**GENOA CHARTER TOWNSHIP
PLANNING COMMISSION
PUBLIC HEARING
SEPTEMBER 14, 2026
MONDAY, 6:30 P.M.
AGENDA**

Attention:	Amy Ruthig, Planning Director
Subject:	Lorentzen PUD – Amendment to an Approved PUD (Review #2)
Location:	West side of Latson Road, north of Grand River Avenue
Zoning:	MUPUD Mixed Use Planned Unit Development

**Re: Meijer Outlot Retail Center
Site Plan Review No. 2**

SHEET
C3.1

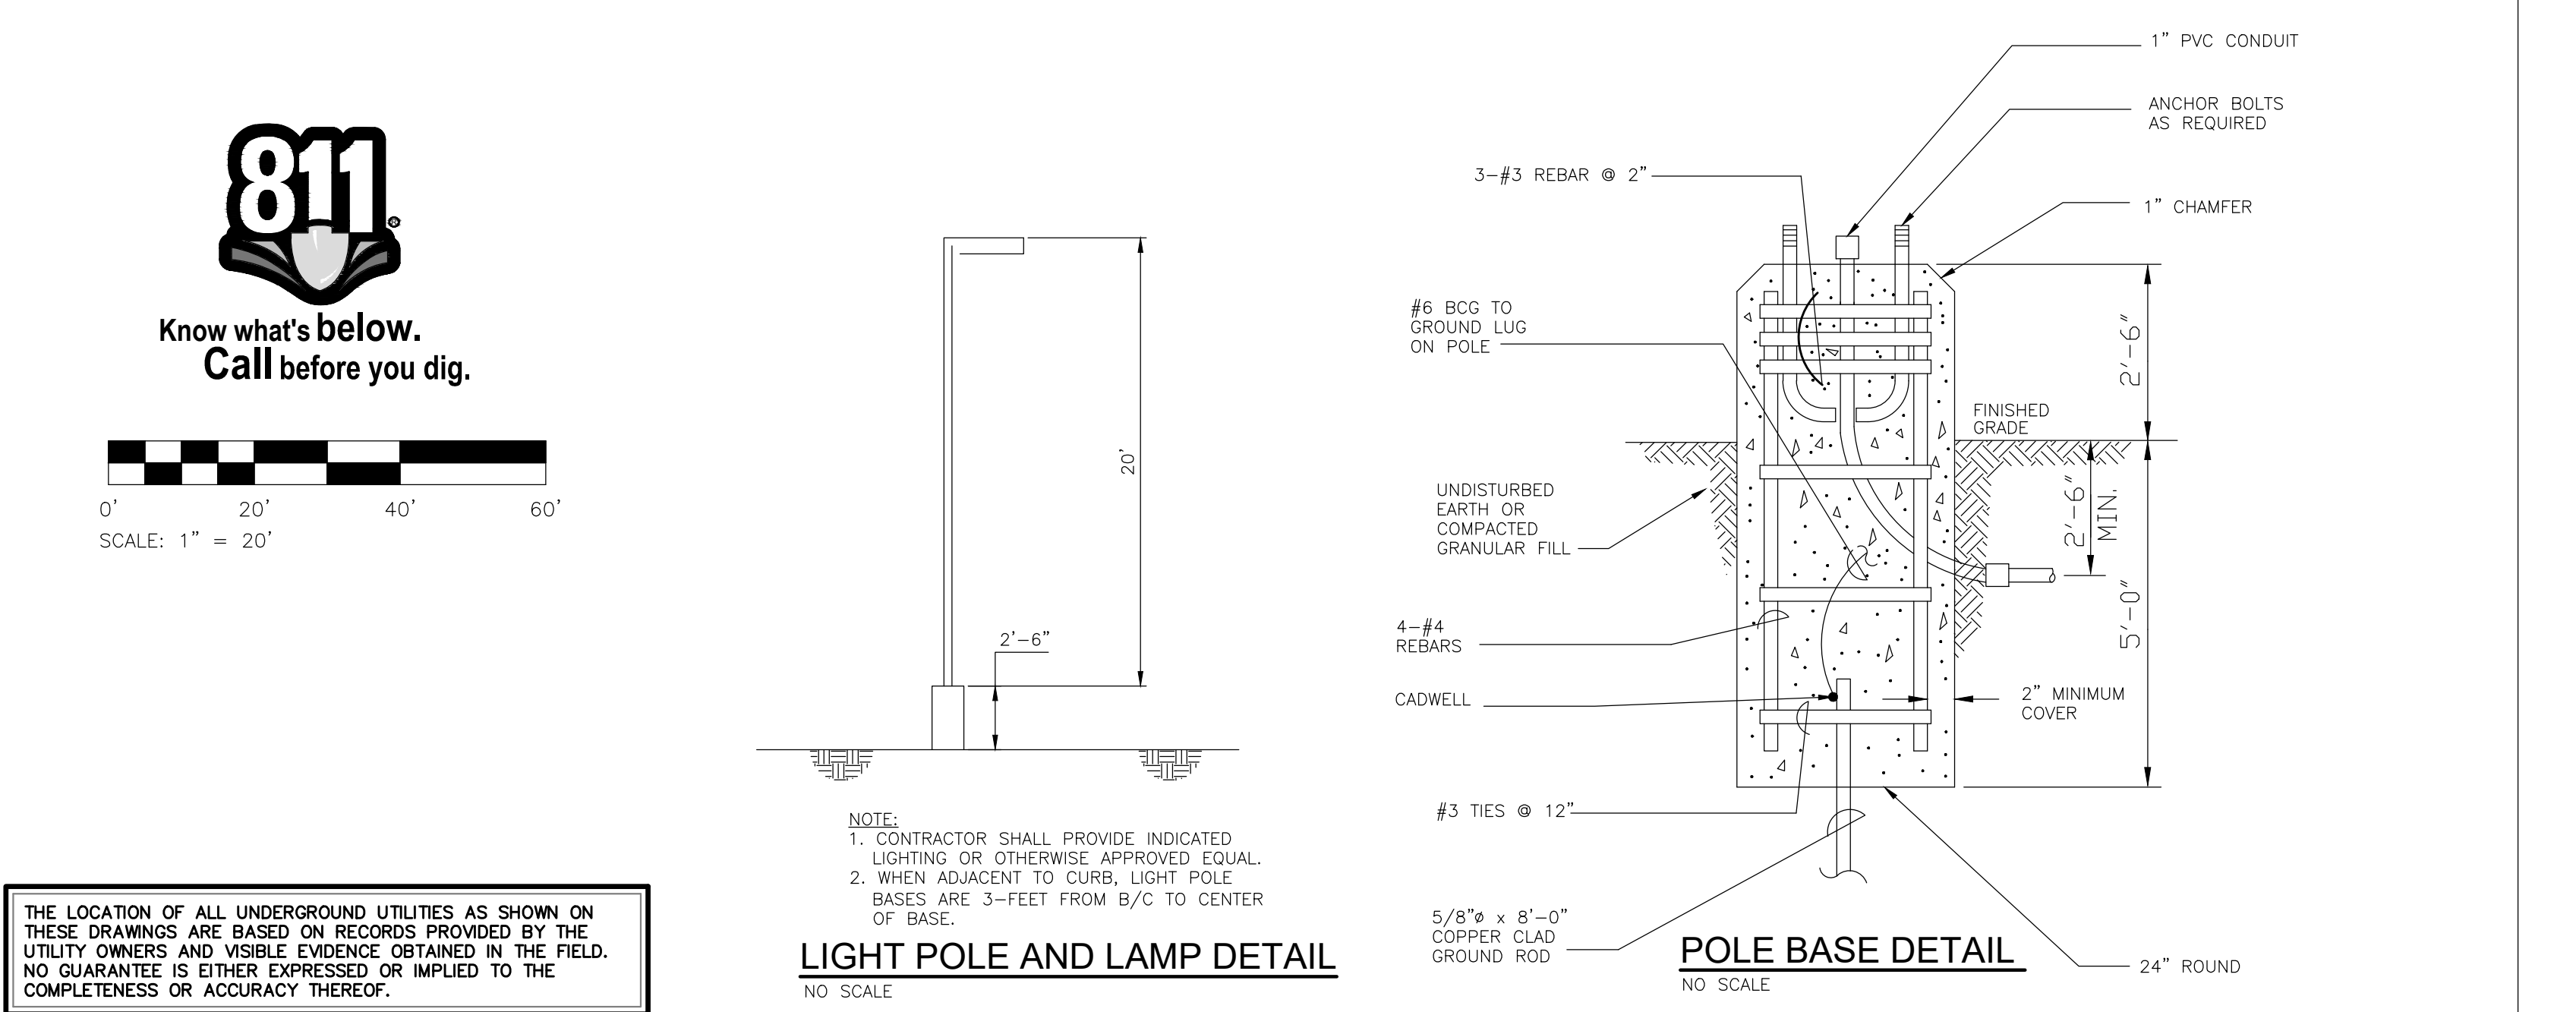
It is unclear whether the remainder of the Meijer site requires a parking deviation. The applicant should provide calculations to determine whether this is necessary.

- Based on the calculations provided on Sheet C3.1, the proposed Outlot will provide 45.3% pervious surface, which exceeds the 25% minimum open space requirement. As previously noted, there is an existing bike path along Latson Road that provides linkages to other sites/amenities in this area of the Township. As a site that currently contains a parking lot, we do not foresee an issue with the amount of usable upland area as part of the open space.

SHEET
C3.2

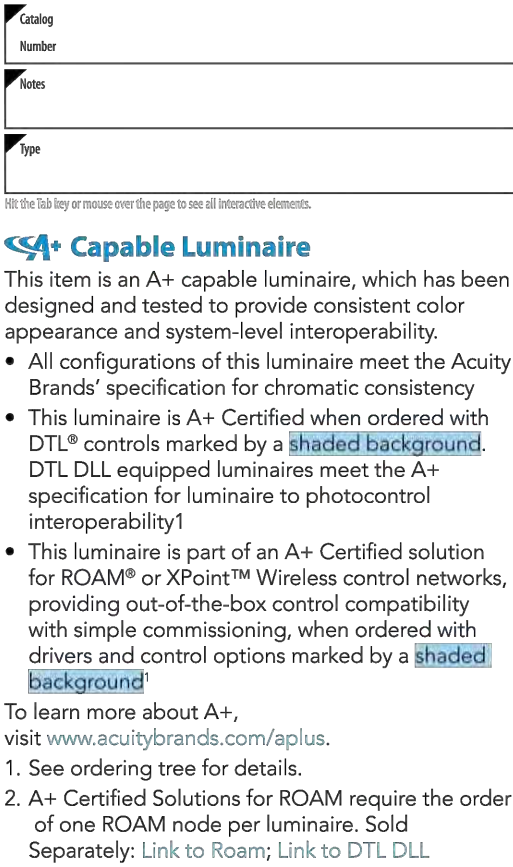
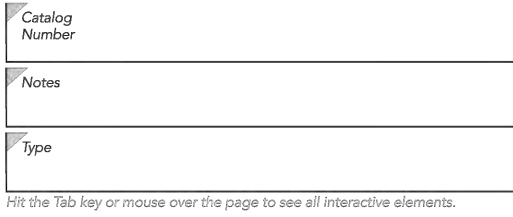
- *Lighting.* The lighting plan is generally consistent with the requirements of Section 12.03; however, there is spill-over to the west in excess of Ordinance standards. In response, the applicant has indicated that the lighting is intended to serve both developments. In our opinion, this should be acceptable; however, it should be addressed as a dimensional deviation in the amended PUD Agreement.

ELEVATION

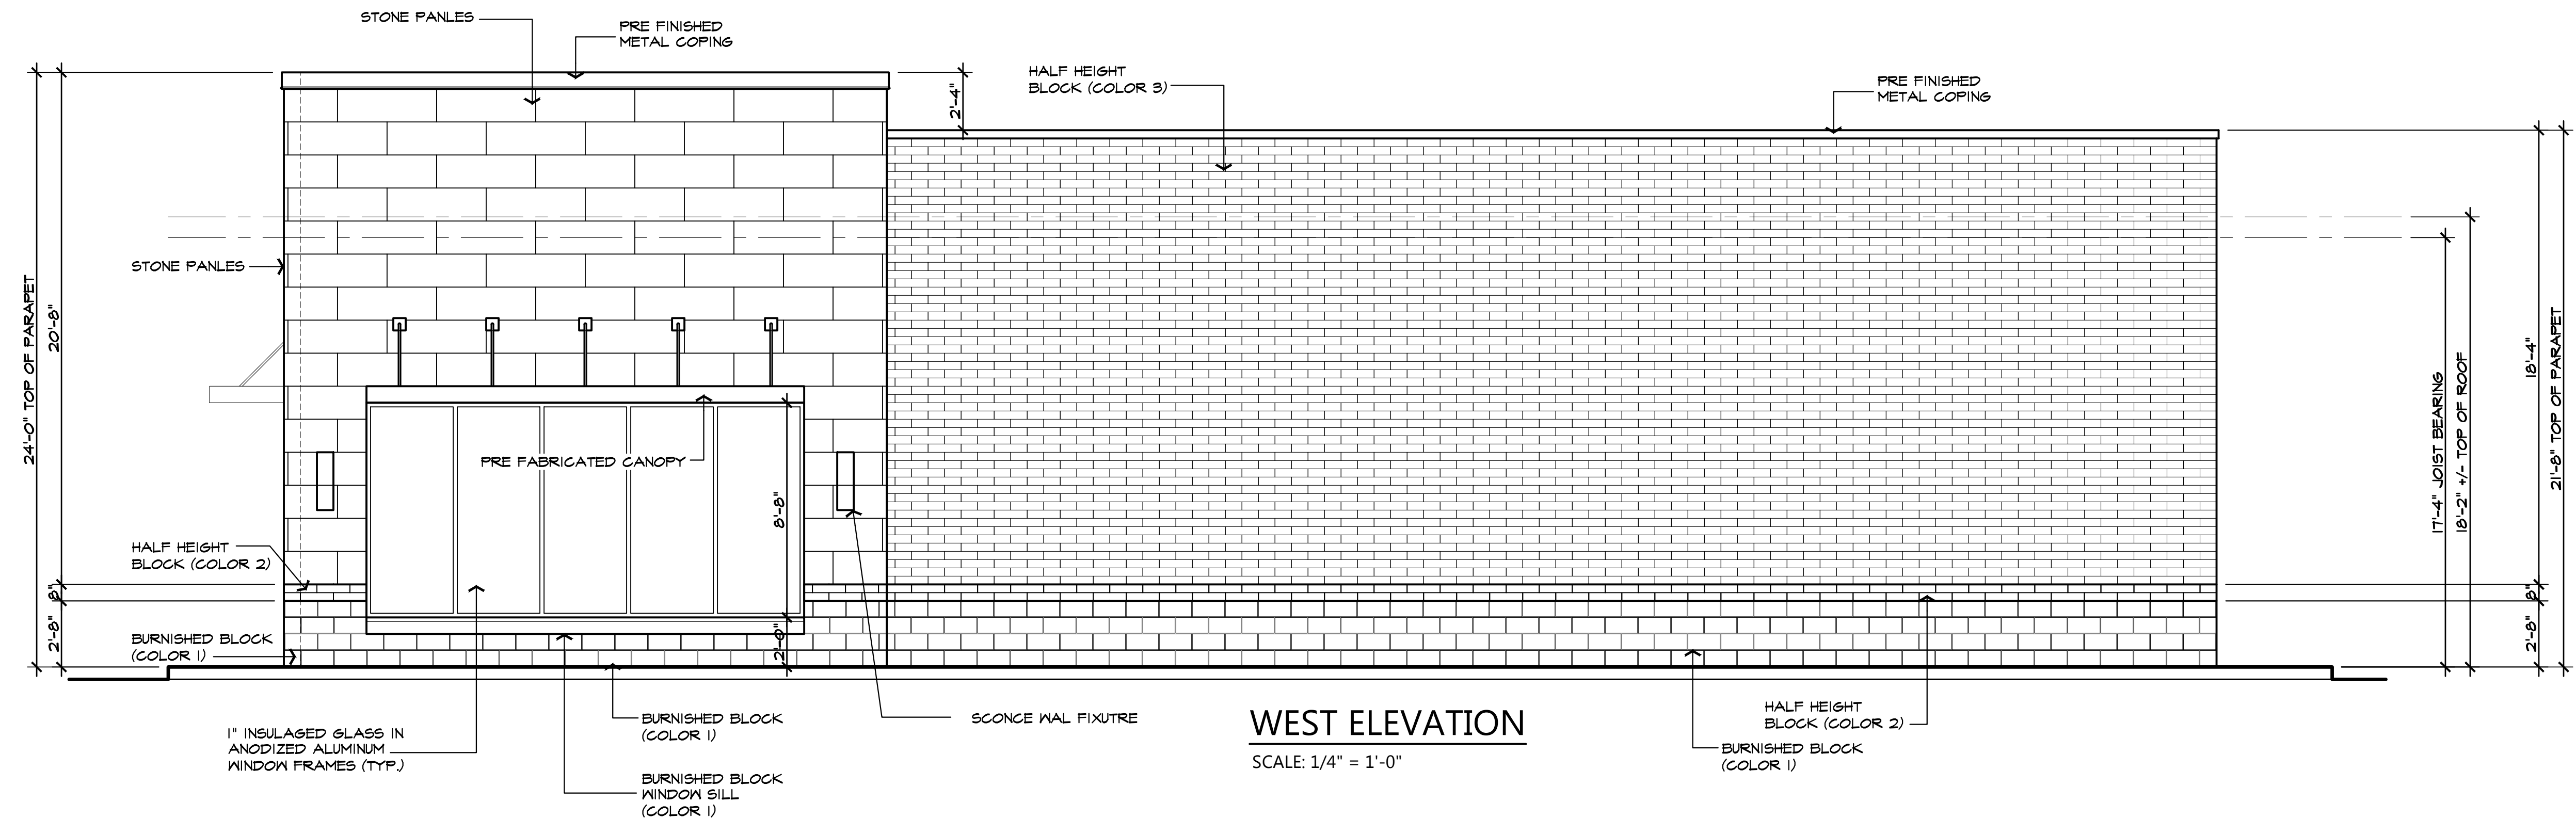
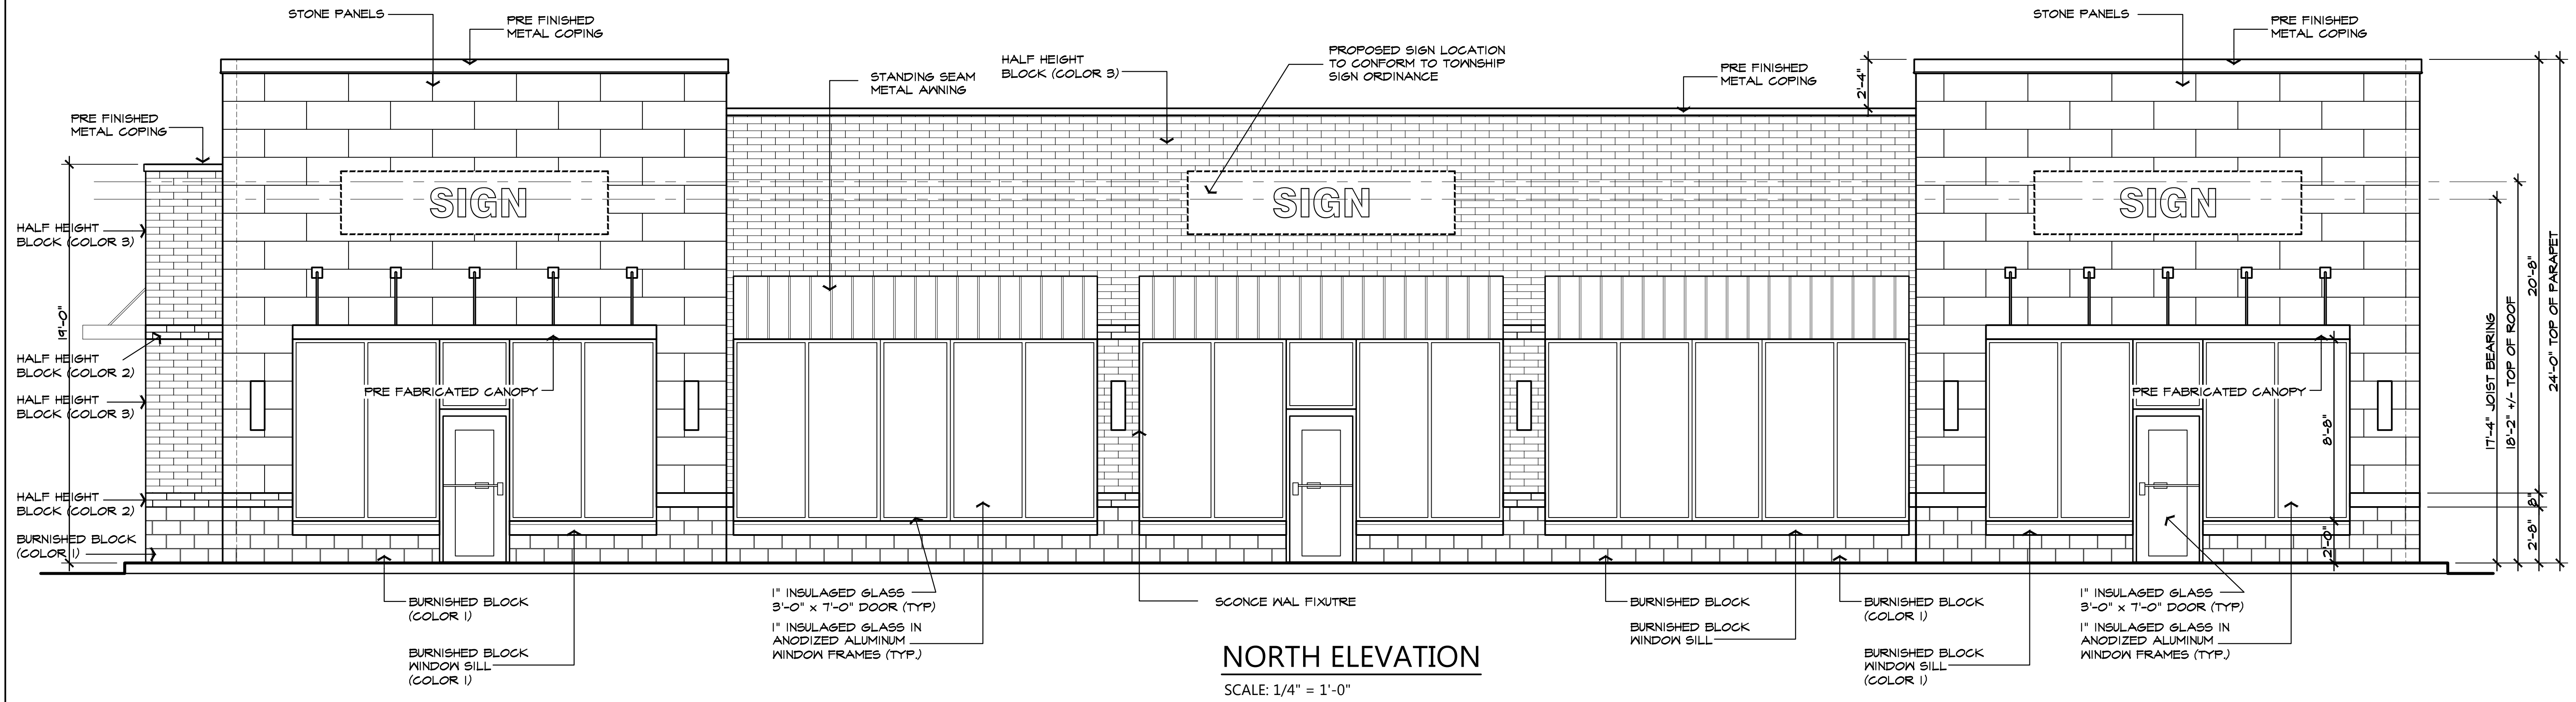
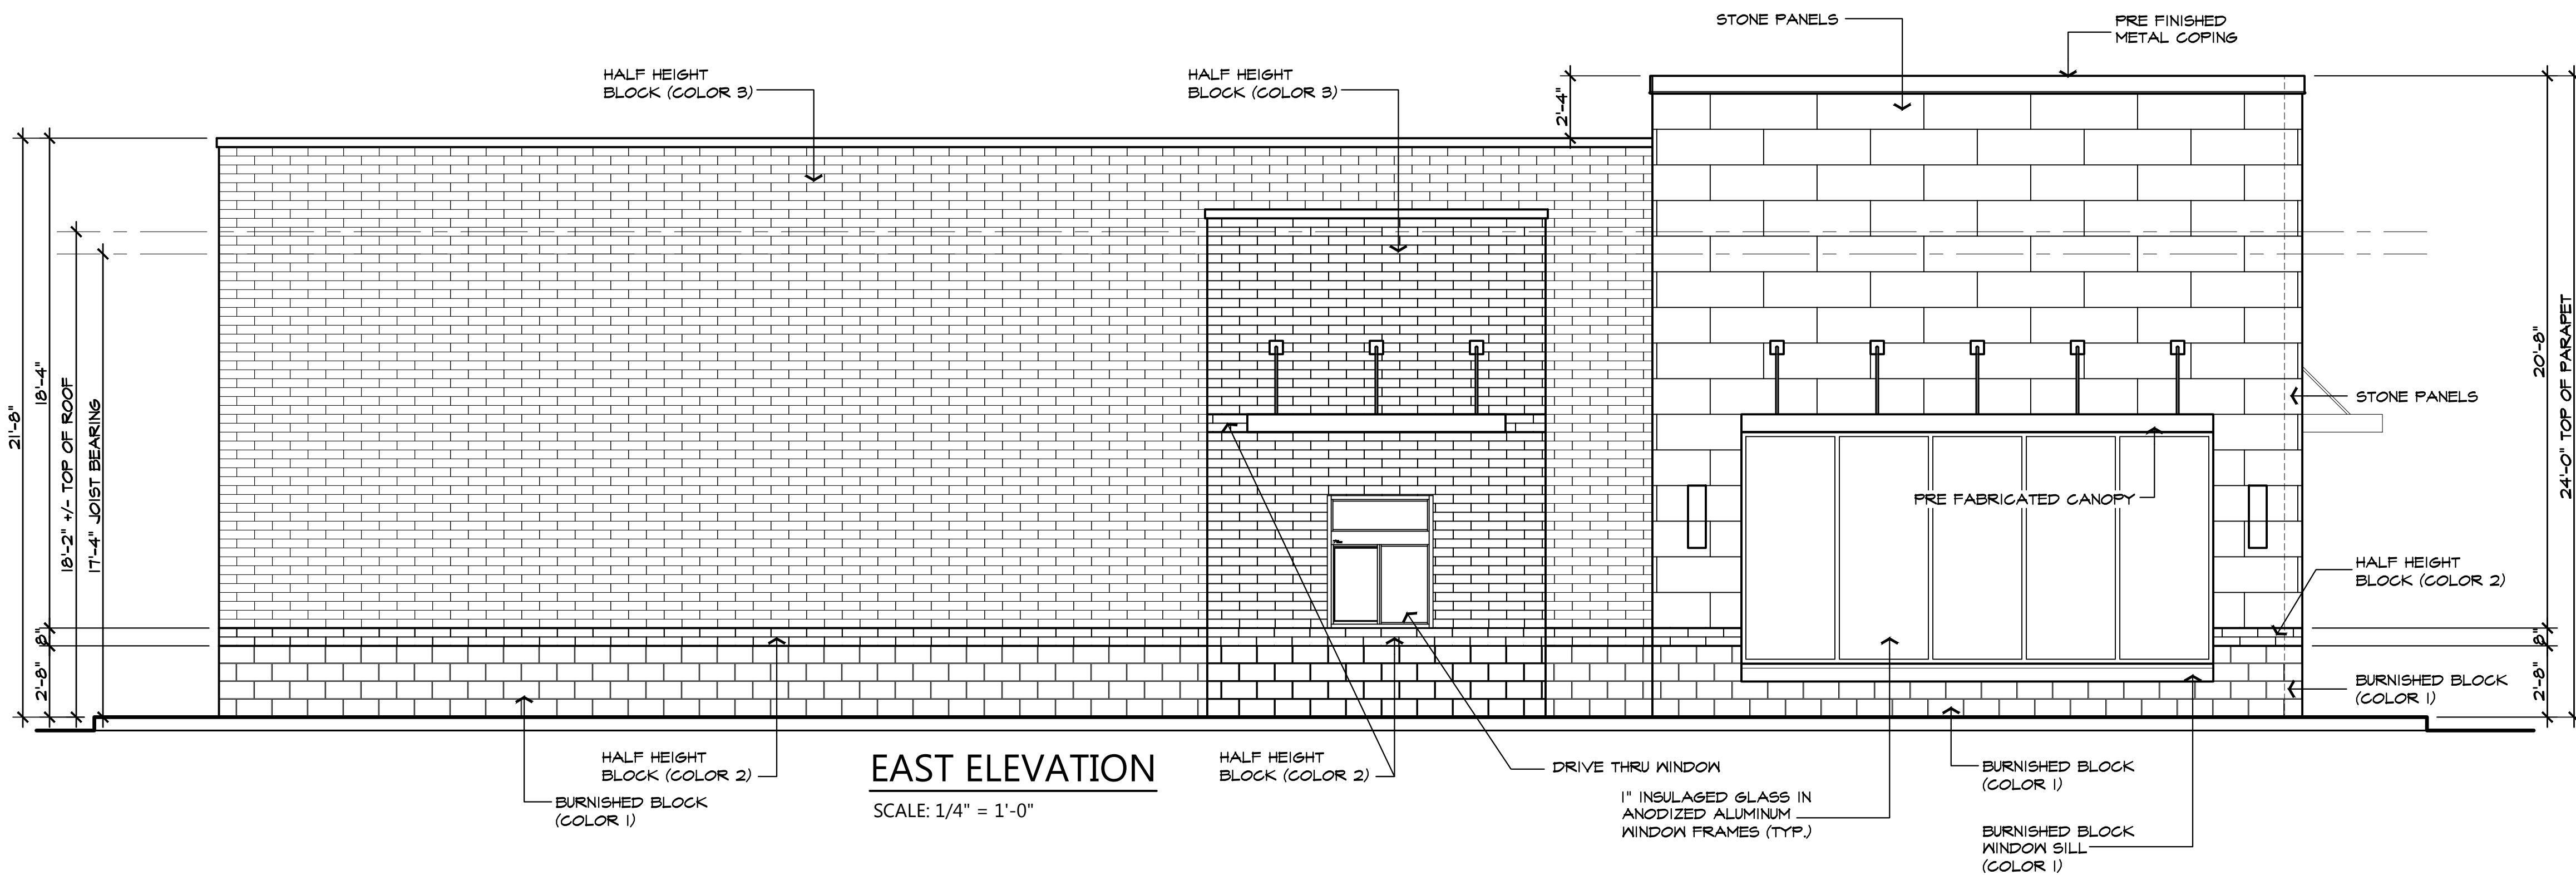
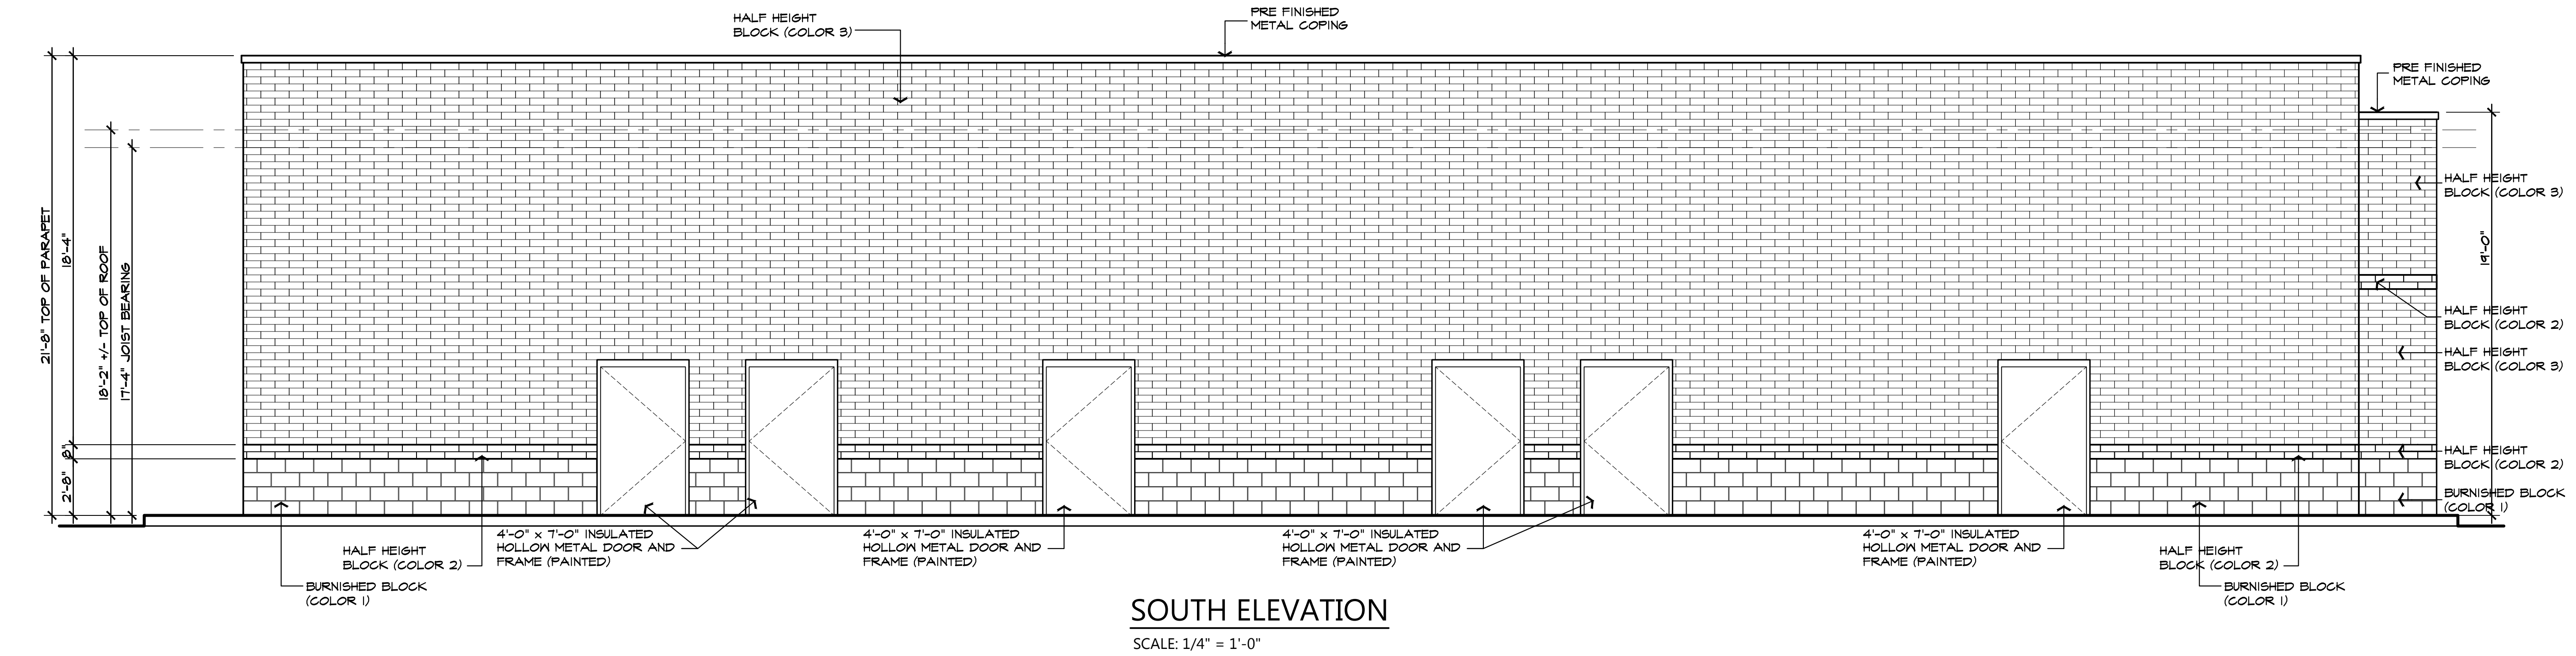
- *Building.* The building is faced with masonry materials with decorative awnings and canopies. The applicant will need to provide a color rendering and building material samples for the Commission's consideration.
